D-206.05

RE: Dauphin River First Nation Environmental Act Proposal for Wastewater Treatment Lagoon Construction Liner Alteration

enc. Plan L3 - Dikes Details - Revision 1

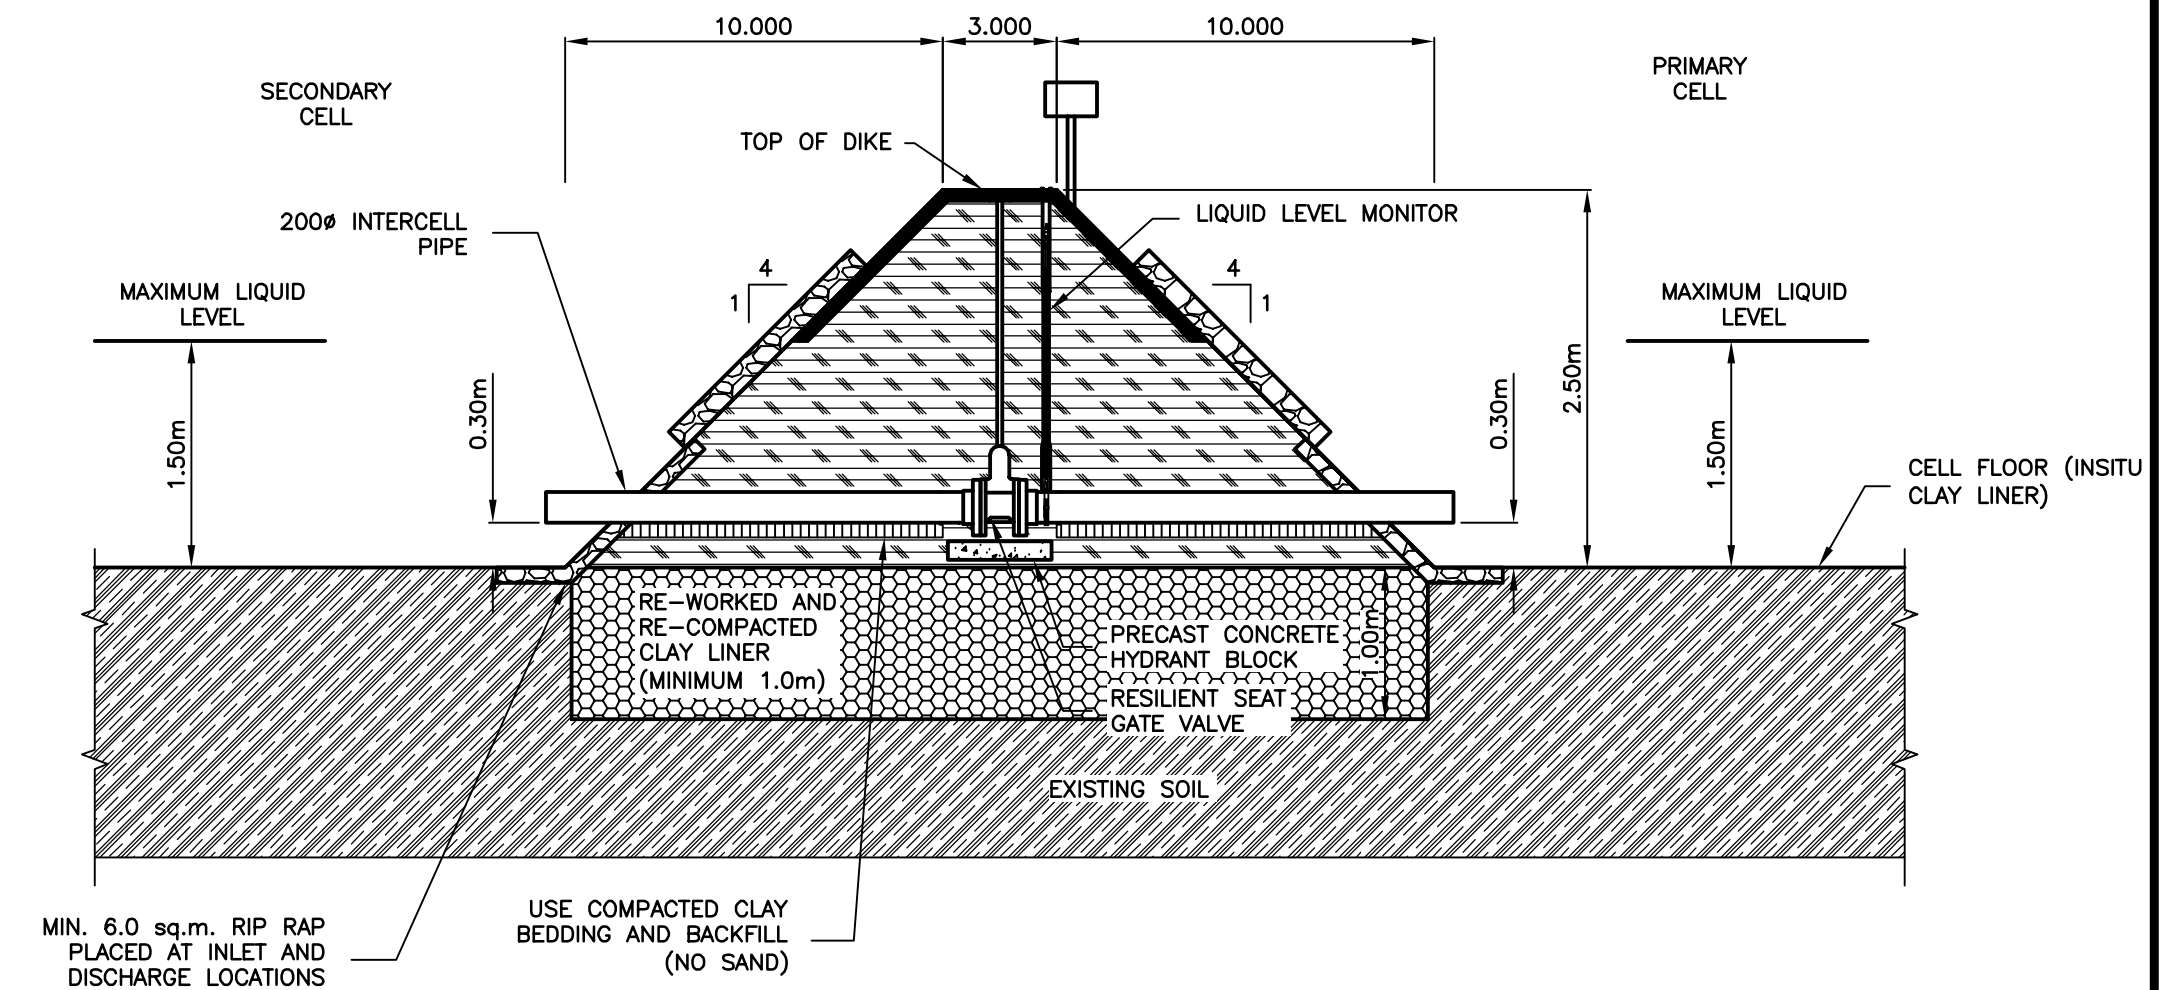
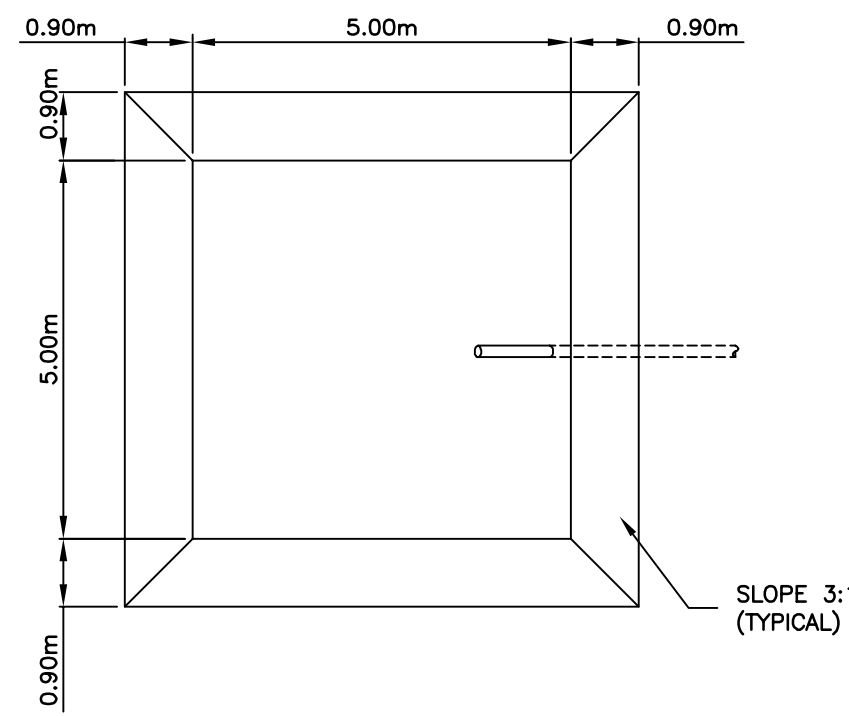
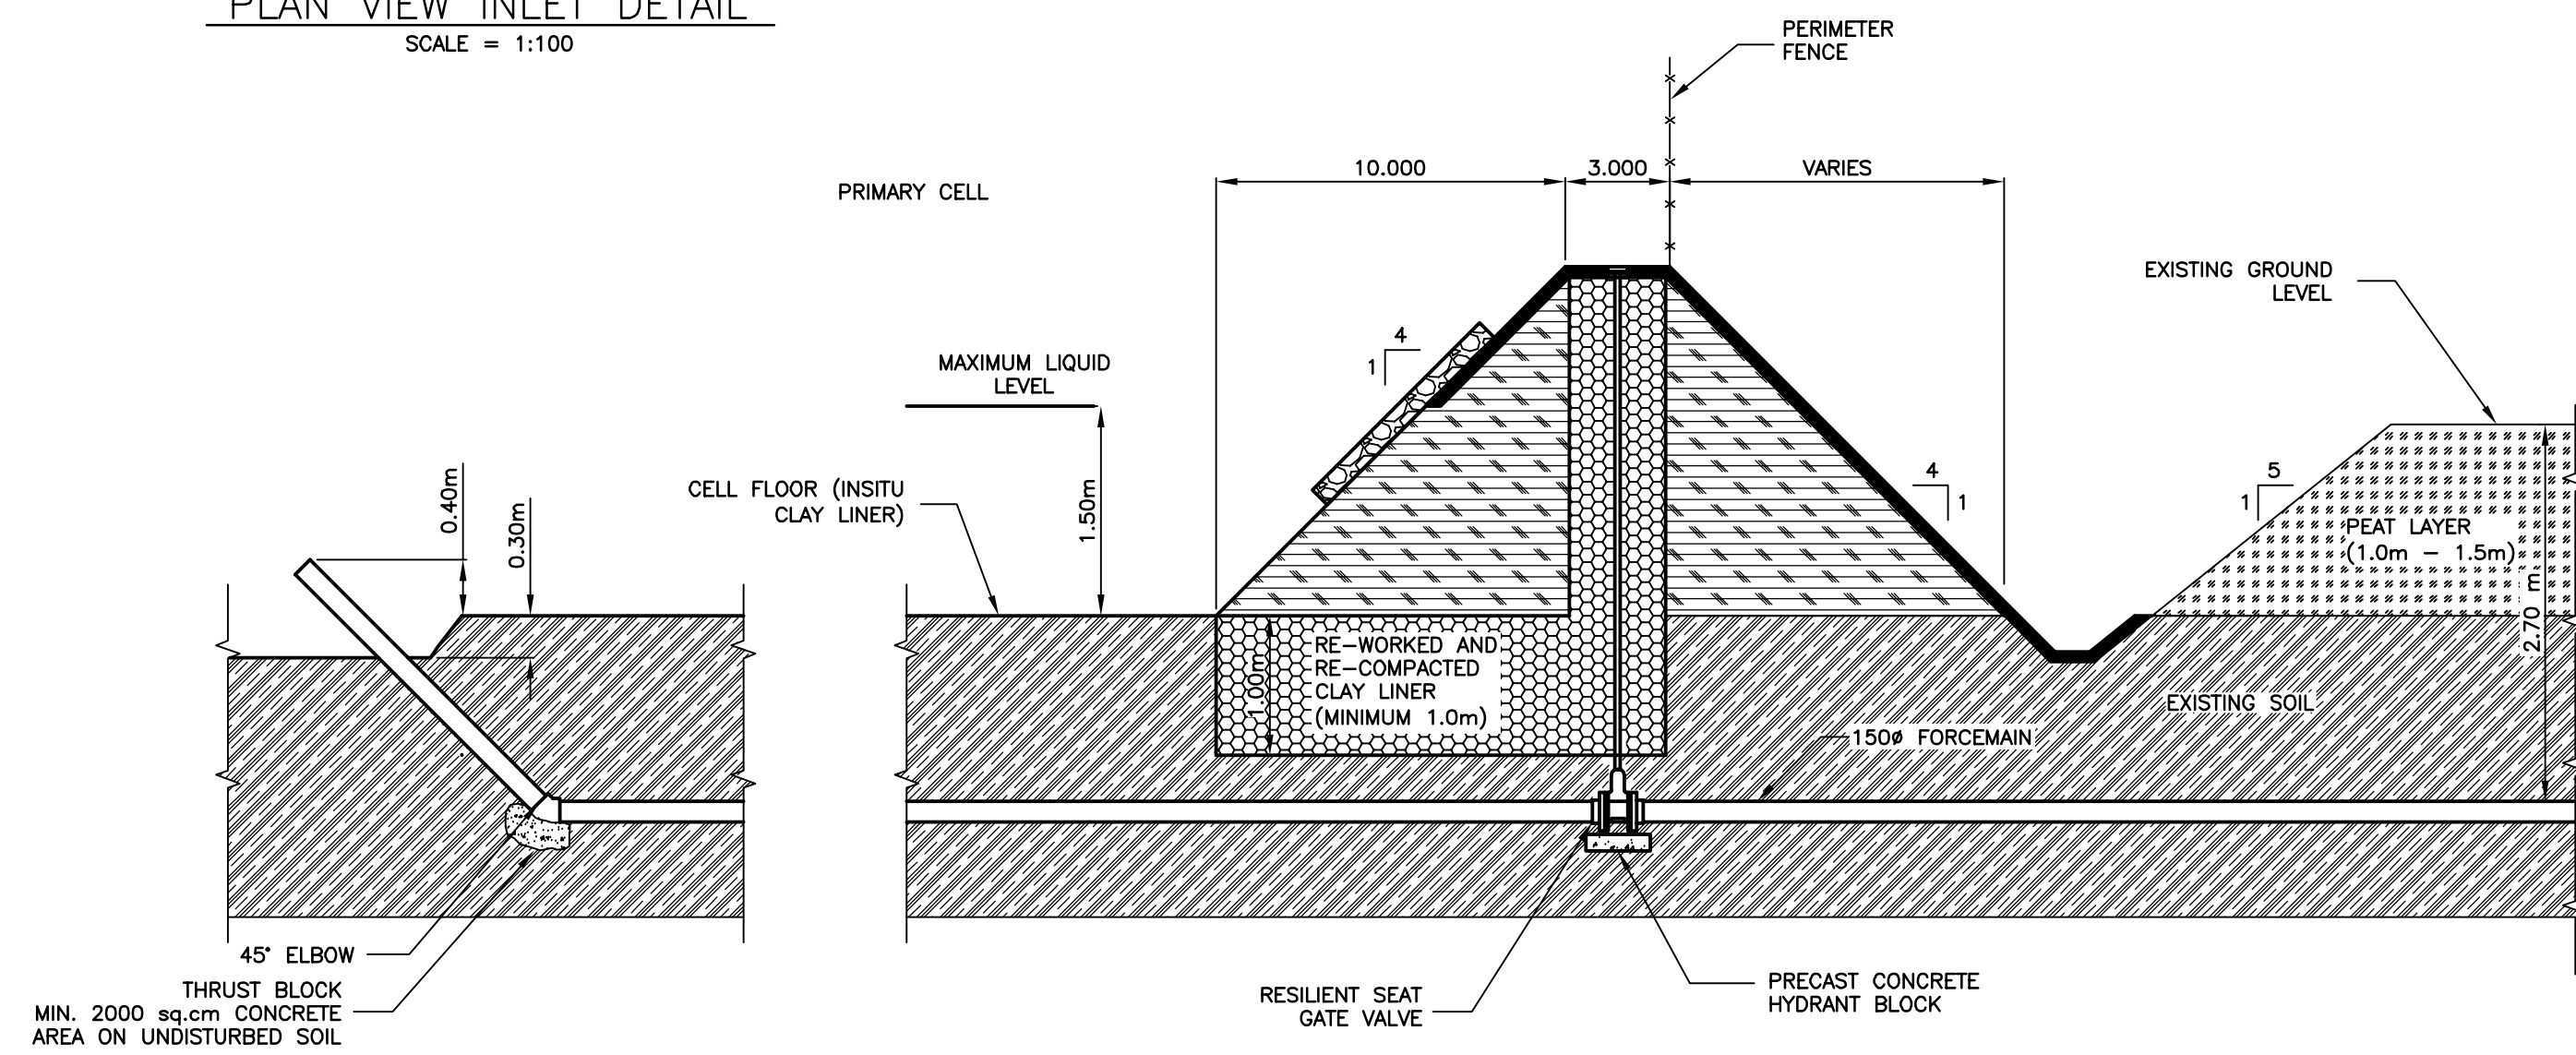
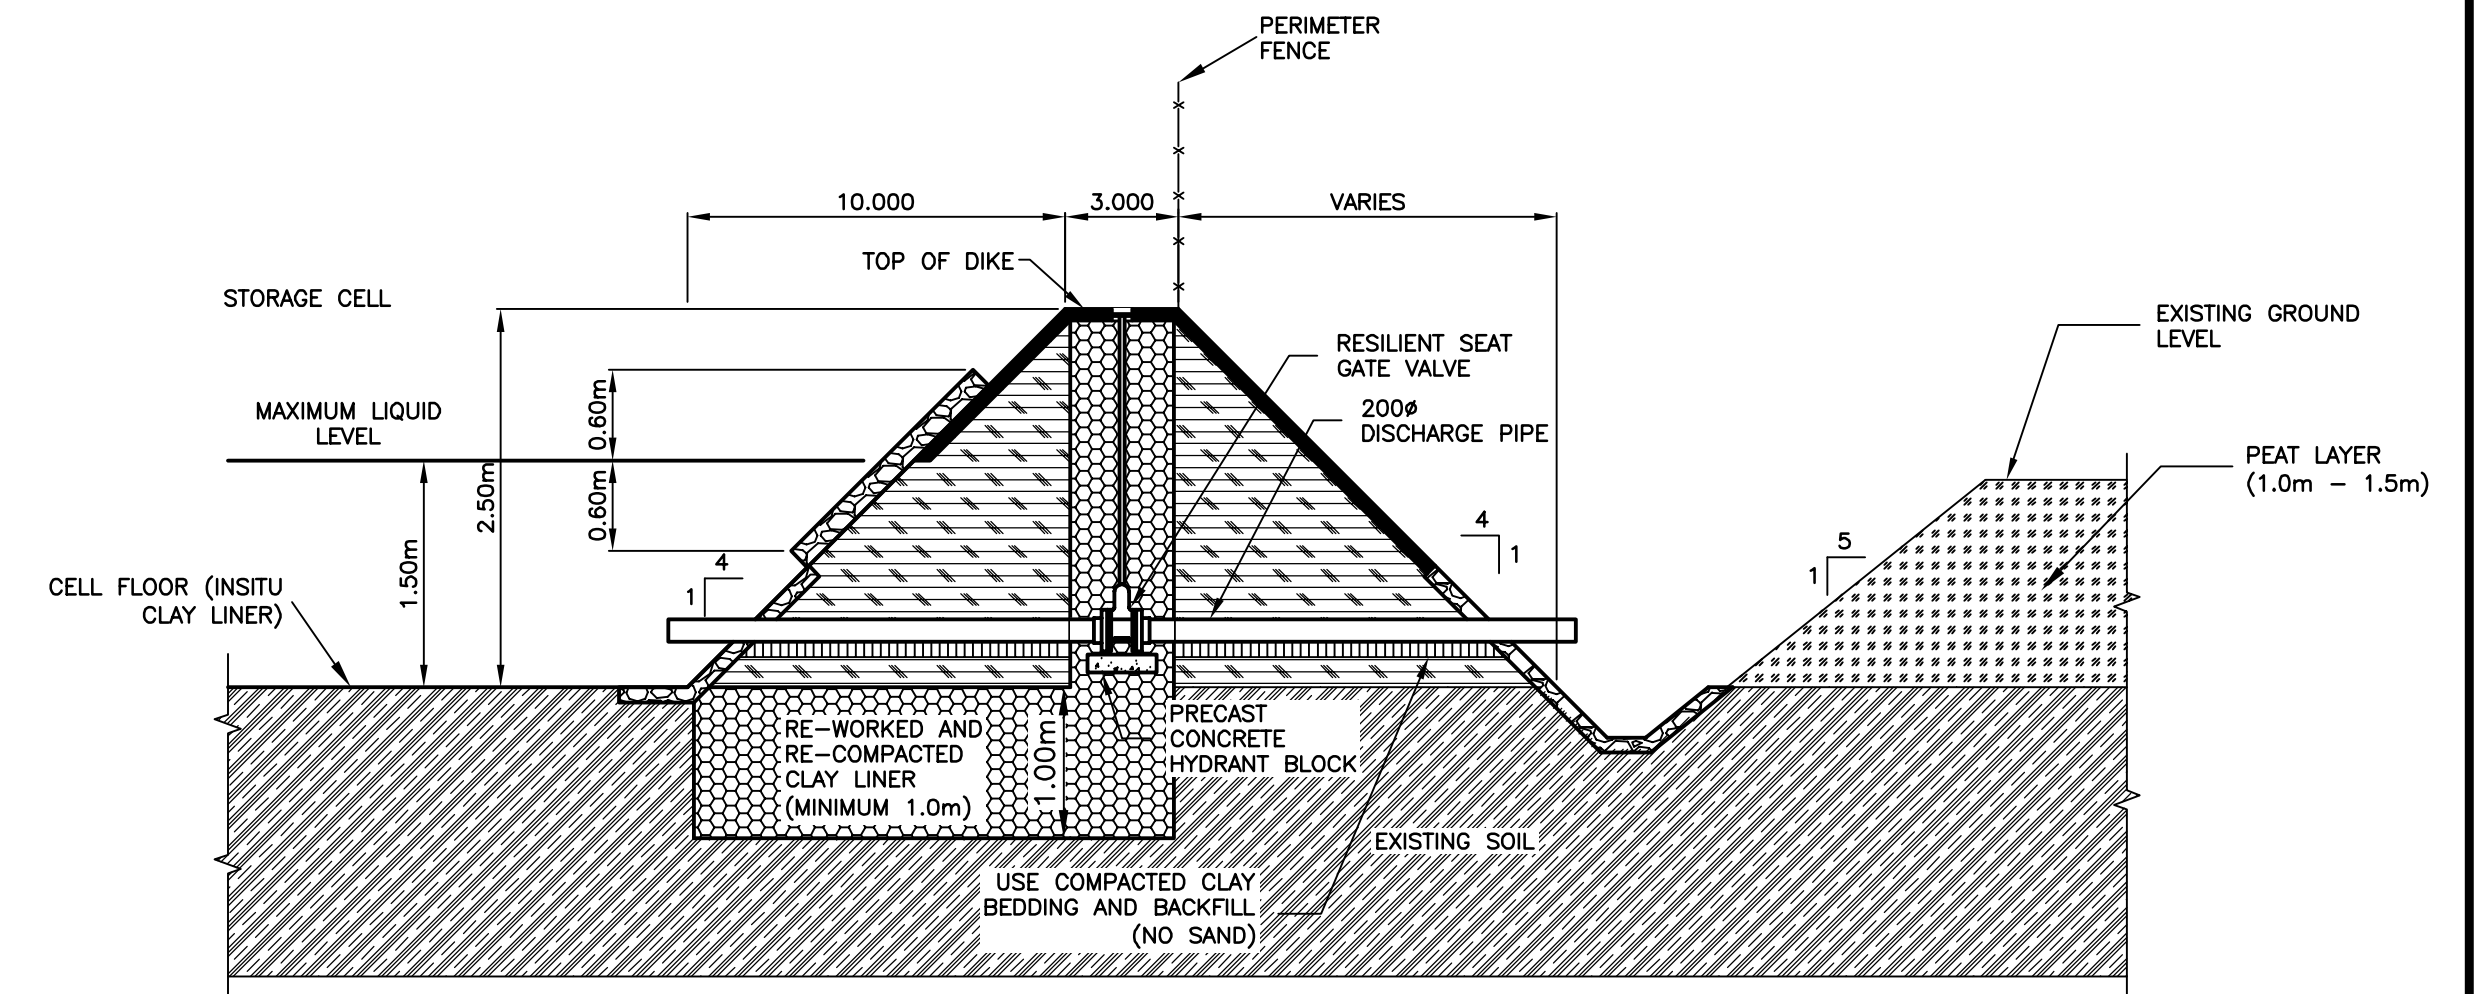
The initial Environmental Act Proposal submitted for the Dauphin River First Nation lagoon identified a 1 m thick remolded clay liner. Since the original submission in April 2015 additional geotechnical investigations have been completed onsite, along with additional design works.

During the geotechnical investigation completed by AMEC Foster Wheeler in April 2015 and subsequent testing completed in May 2015, tests results show samples collected of the insitu clay soils meet the liner requirements of 1×10^{-7} cm/s. Instead of remolding the entire site as presented in the original EAP, the design has changed to only remold 1 m thick the soil under the keyway and inside slope of the perimeter dikes and under the intercell dike. (as identified on the attached plan L3) Should areas be found to have insufficient depth of clay during the excavation of the lagoon perimeter remolded liner, additional excavation will continue into the cell floor to confirm the availability of the minimum 1 m thick insitu clay liner.

B.M. EL.
1	LINER REVISION	15/10/02	RH	LOCATIONS OF UNDERGROUND STRUCTURES/UTILITIES AS SHOWN ARE BASED ON AVAILABLE INFORMATION BUT NO GUARANTEE IS GIVEN OR IMPLIED THAT ALL EXISTING UNDERGROUND STRUCTURES/UTILITIES ARE SHOWN OR THAT THE GIVEN LOCATIONS ARE EXACT. CONFIRMATION OF EXISTENCE AND EXACT LOCATION OF ALL UNDERGROUND STRUCTURES/UTILITIES MUST BE OBTAINED FROM THE APPROPRIATE AUTHORITY/OWNER, BY THE CONTRACTOR, BEFORE PROCEEDING WITH CONSTRUCTION.					
No.	REVISIONS	DATE	INITIALS
